<u>2nd Preliminary Consultation</u> <u>MONTGOMERY COUNTY HISTORIC PRESERVATION COMMISSION</u> STAFF REPORT

| Address: | 3100 Brimstone Academy Dr., Olney | Meeting Date: | 7/10/2019 |
| Resource: | Master Plan Site #23/97 Rockland | Report Date: | 7/3/2019 |
| Proposal: | Building Addition | | |

Figure 5: Floor plan showing second floor. Original rear of the building high lightened.

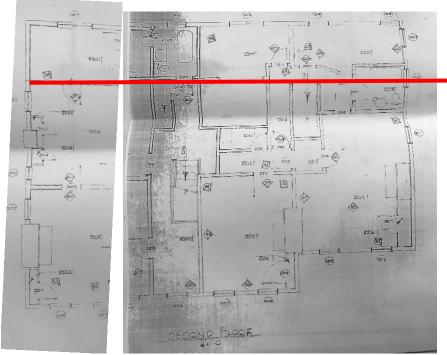
The rear of the house saw more change than the front. Sometime prior to 1900 an almost full width, two-story addition was constructed across the rear of the house. Staff cannot determine the historic purpose of this addition, but by 1985 the space included rooms and a recessed porch on the first floor and bathrooms and additional bedrooms on the second floor. Based on the changes to the interior floor plan, the historic fenestration pattern cannot be discerned. The fenestration as it existed c.1970s (see figures 6 and 7 below) was irregular with a collection of paired windows and large window for the recessed porch/reading room.

Based on the evidence shown in Figures 5, 6, and 7, above, Staff finds there is no historical basis for the existing fenestration pattern. Additionally, all of the windows installed in the house date from 1986 and, at least on the front, required enlarging the openings. As the design, opening size, and materials are not historic, Staff finds that the evaluation of the proposal must rest on the visual impact this work will have on house.

Figure 8: Left elevation c.1975 showing side porch and two-story rear addition prior to the reconstruction of the wing in 1986.

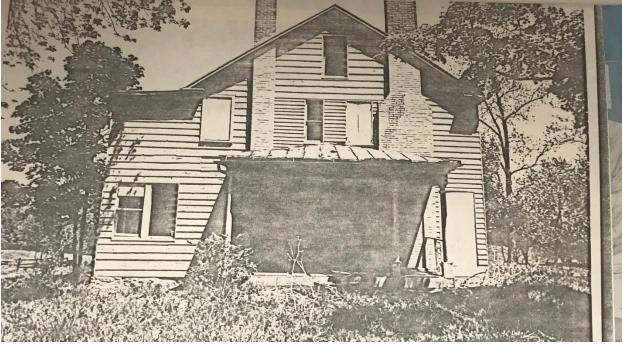
Staff finds that a building addition in this location is acceptable. It is in the rear of the building connecting to a c.1980s addition. Figures 3 and 6, above, show that the subject property has historically utilized co-planer additions to the side wing additions. No photographs of the rear of the left side exist to show if there is a precedent for this type of addition on this side of the house. Typically, additions are required to be inset from the existing construction to differentiate the historic from the new construction. Because the existing wing is a c.1980s construction, Staff could reasonably support a co-planer addition either with or without the corner board trim piece. An alternative design solution would be to inset the wall of the addition from the existing wall. Staff request feedback from the HPC on the appropriateness of a co-planer addition and the proposed exterior wall treatment.

Figure 11: View of the window in the bathroom space prior to the 1986 renovation.

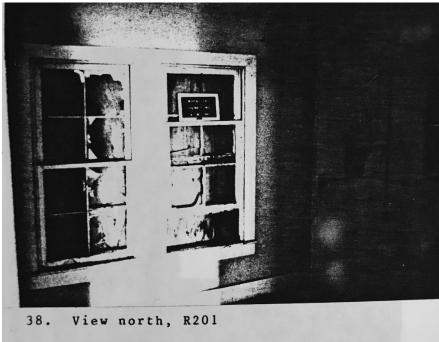
If the HPC determines that the proposed addition is appropriate, the removal of the bathroom windows will not be at all visible from any public right-of-way, on the rear, and Staff finds that that work should approved almost as a matter of course. Even if the proposal is evaluated independent of the addition, Staff finds that this alteration to the rear will not substantially alter the historic character of the house nor will it impact the historic character. In fact, prior to 1986, the window in the bathroom was a pair of boarded up, four-over four sash windows (Fig. 11, below). In further analyzing this proposal Staff evaluated employing smaller windows in this space to maintain the ration of solids to voids. Staff's conclusion was that introducing a new window size would introduce more complexity to the rear that would detract from the regularly sized openings in the rear.

Staff finds that a full existing rear elevation needs to be submitted with the HAWP application to allow the HPC to make a final determination as to the window removal's appropriateness.
